Note
 3" Asphalt macadam surface course
 3" (loose) #2 rock, 1 1/2 gals. asphalt per sq. yd.,
 sufficient #3 rock to fill voids and cover
 ROAD SECTION ON TANGENT
 STA. 705+37.75 to 725+00

4000.SPECIAL

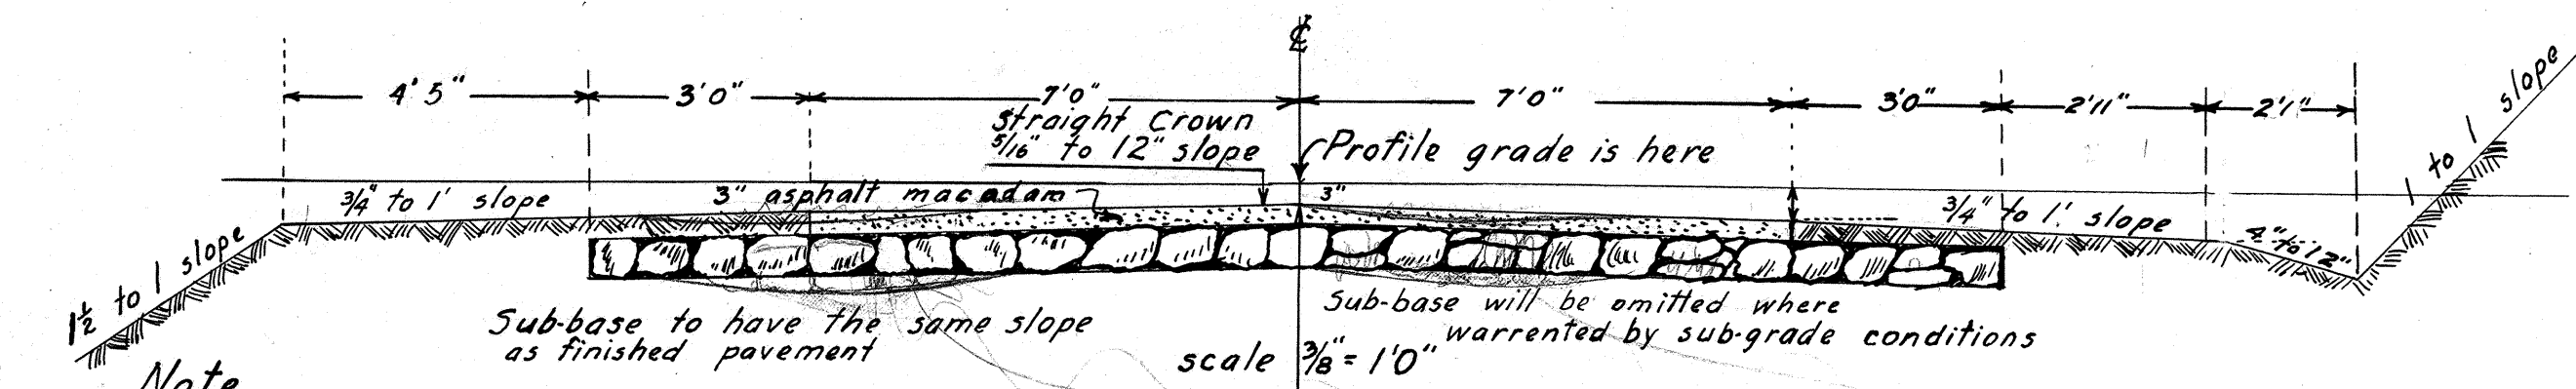
Project is now divided as follows
 Group A sta. 246+00 to 705+37.75 with typical sections to be as shown on sheet 4000.2
 Group B sta. 705+37.75 to 725+00 with typical sections to be as shown at left

show base and pavement
 depressed about 1/2" at these
 points on the typ. section
 existing detail
 heavy for new
